PRELIMINARY DRAWING	APPROVED		DTE ELECTRIC COMPANY REGIONAL PLANNING	
			LAYOUT BY	Zein Hassan
			DATE	9/1/2026
			SCALE

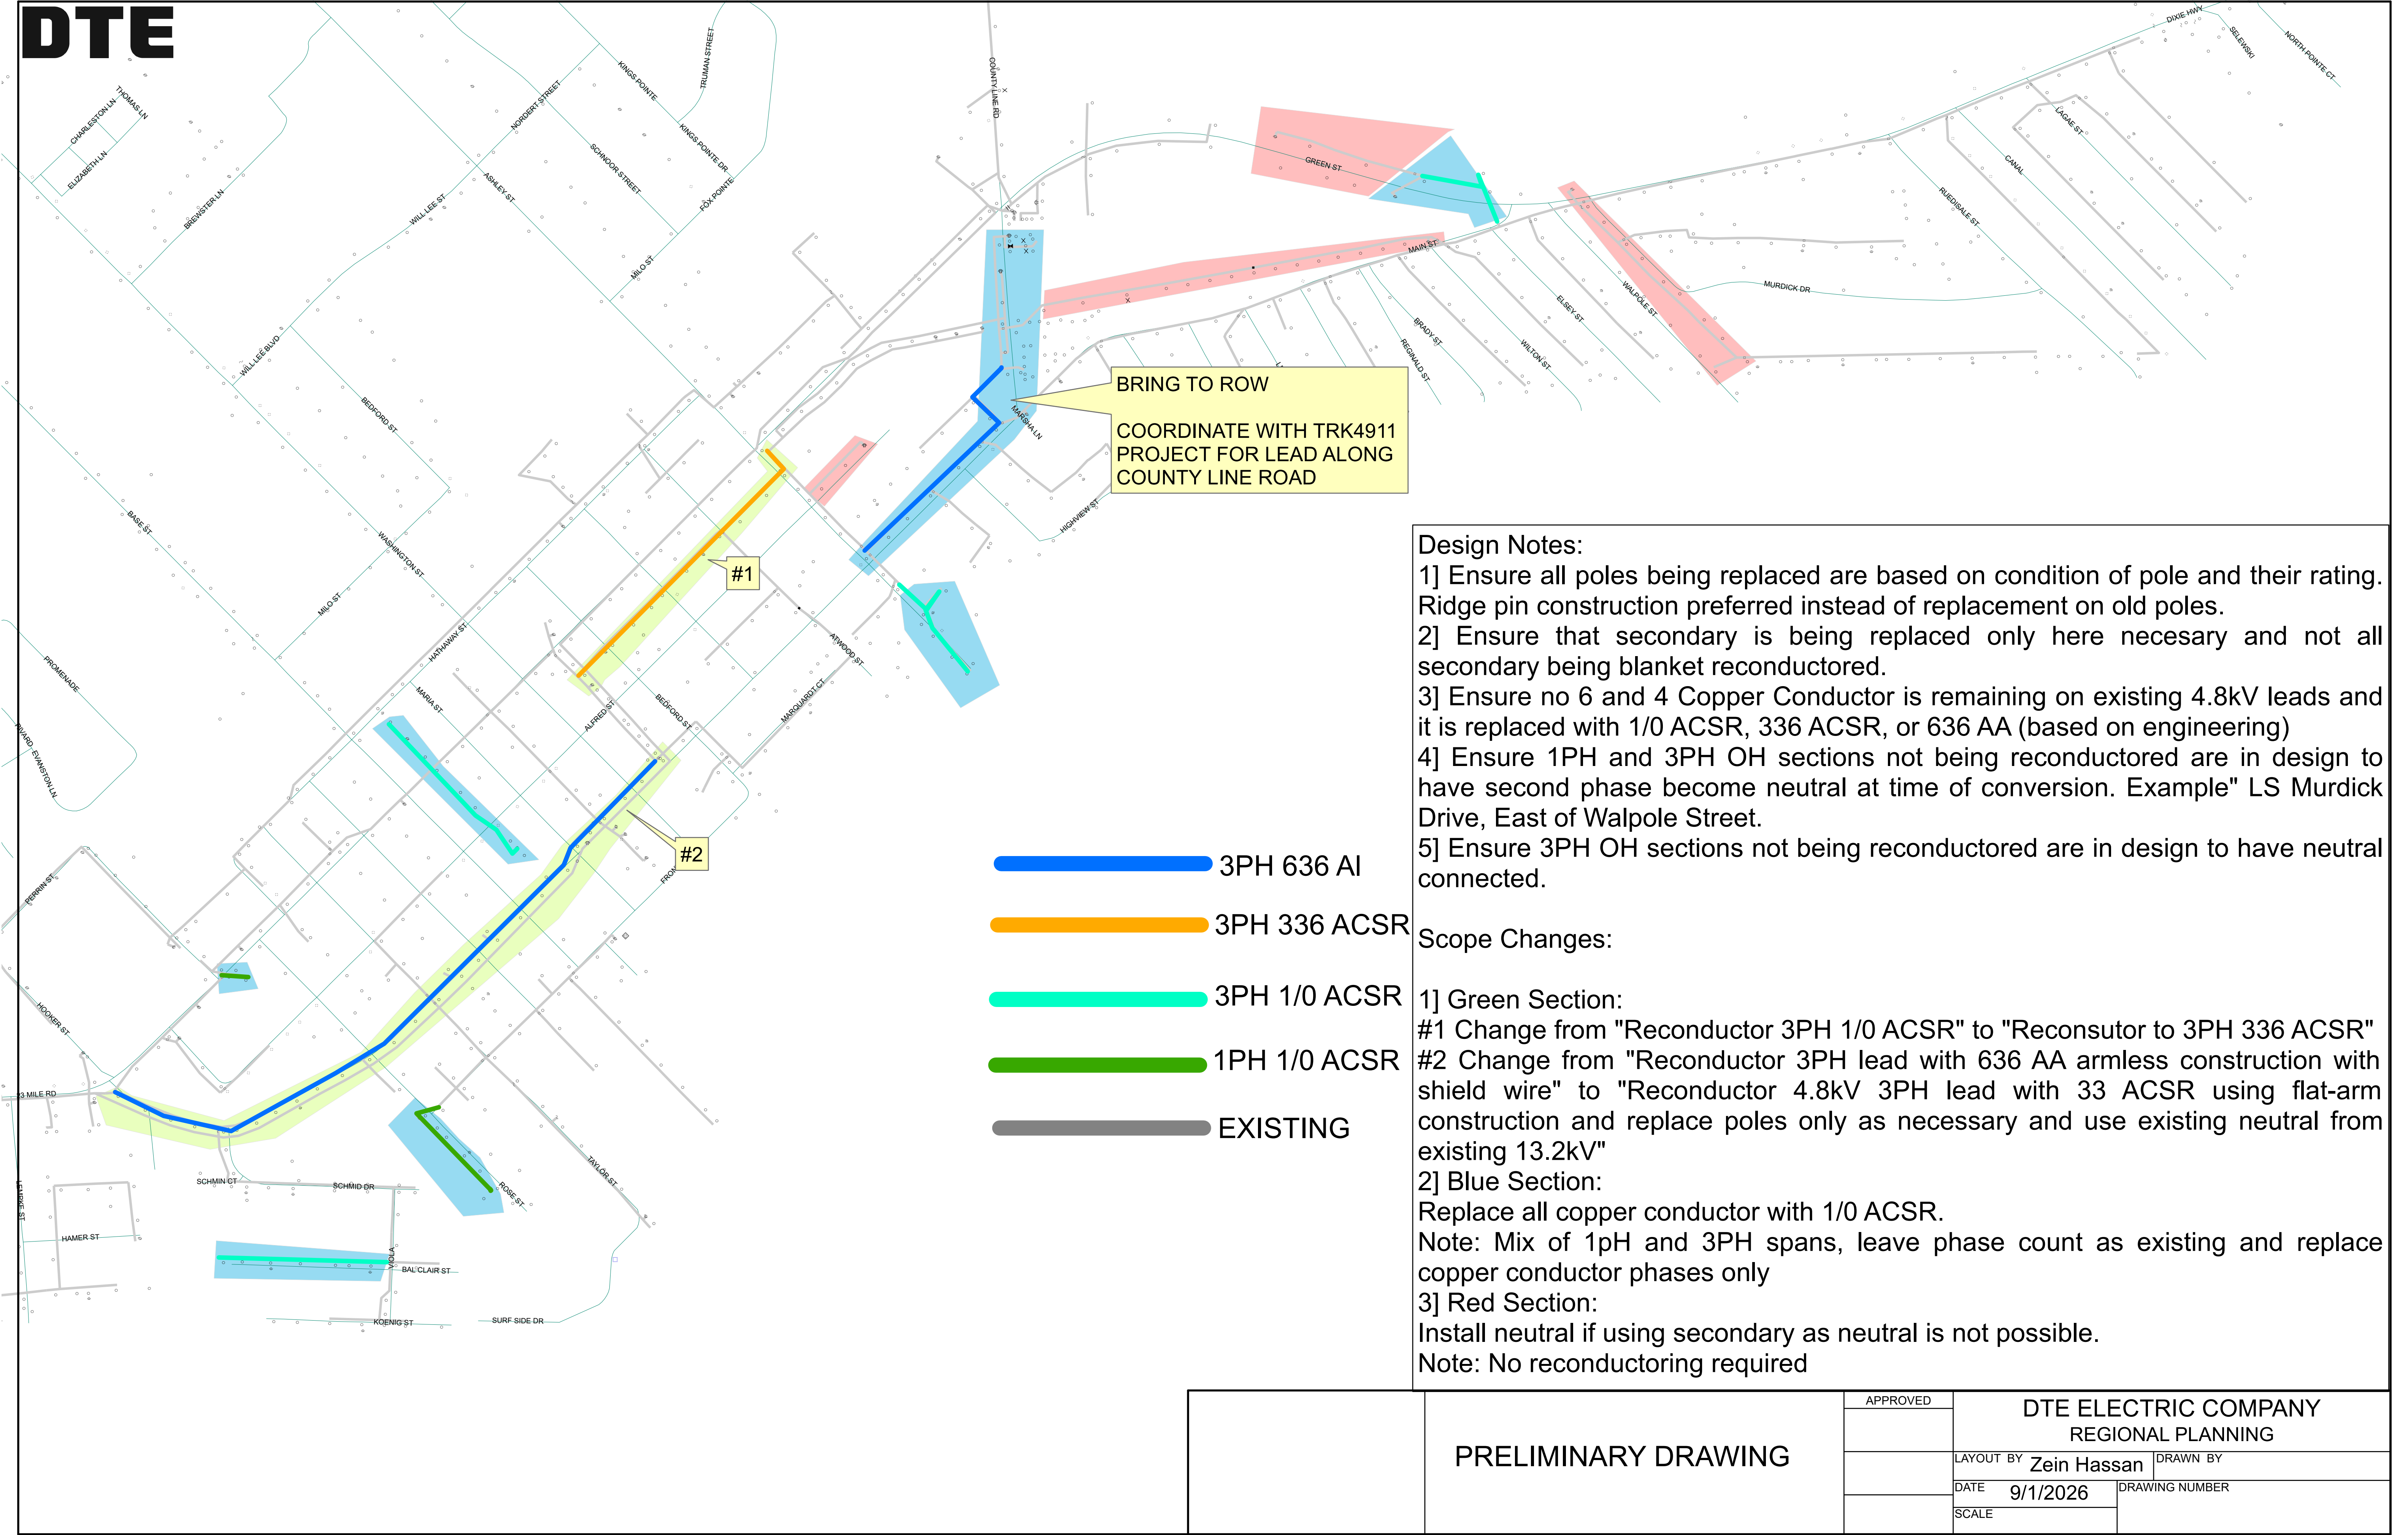
1] Ensure all poles being replaced are based on condition of pole and their rating. Ridge pin construction preferred instead of replacement on old poles.

2] Ensure that secondary is being replaced only here necessary and not all secondary being blanket reconnected.

3] Ensure no 6 and 4 Copper Conductor is remaining on existing 4.8kV leads and it is replaced with 1/0 ACSR, 336 ACSR, or 636 AA (based on engineering)

4] Ensure 1PH and 3PH OH sections not being reconnected are in design to have second phase become neutral at time of conversion. Example" LS Murdick Drive, East of Walpole Street.

5] Ensure 3PH OH sections not being reconnected are in design to have neutral connected.

1] Green Section:
#1 Change from "Reconductor 3PH 1/0 ACSR" to "Reconsutor to 3PH 336 ACSR"
#2 Change from "Reconductor 3PH lead with 636 AA armless construction with shield wire" to "Reconductor 4.8kV 3PH lead with 33 ACSR using flat-arm construction and replace poles only as necessary and use existing neutral from existing 13.2kV"

2] Blue Section:
Replace all copper conductor with 1/0 ACSR.
Note: Mix of 1pH and 3PH spans, leave phase count as existing and replace copper conductor phases only

3] Red Section:
Install neutral if using secondary as neutral is not possible.
Note: No reconductoring required
